**SIB 00 09 13****Change in Maintenance: Check Center Stand**

Subject: Change in Maintenance-Center Stand

Models: All R 1200 (K2x) models with center stand

Example, K25: Checking security of center stand threaded fasteners

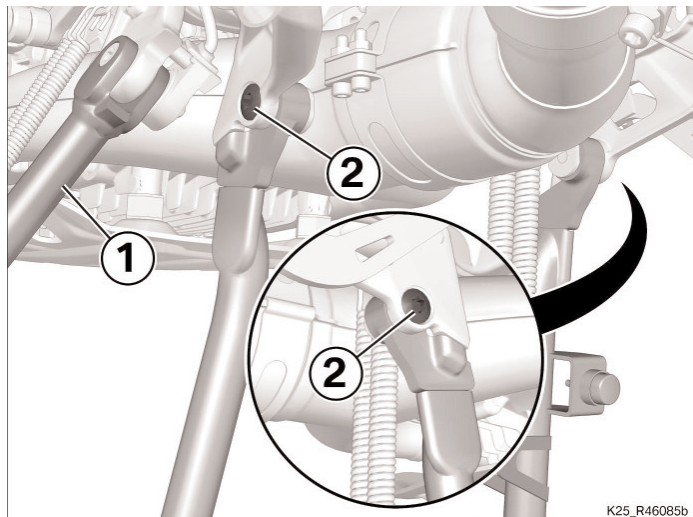
Details: Within the framework of quality monitoring, BMW Motorrad has ascertained that incorrect usage, such as overloading, can result in the threaded fasteners of the center stand losing their initial torque.

Aftersales solution: In order to prevent consequential damage, checking the security of the center stand threaded fasteners is included as a maintenance item.

Extend side stand (1).

Use a torque wrench to check the security of screws (2) (40 Nm).

If the specified tightening torque is not achieved in the test, the swivel mount of the center stand has to be replaced in accordance with repair item 46 52 558 (see the current RSD (Repair and Service Data BMW Motorrad) DVD).
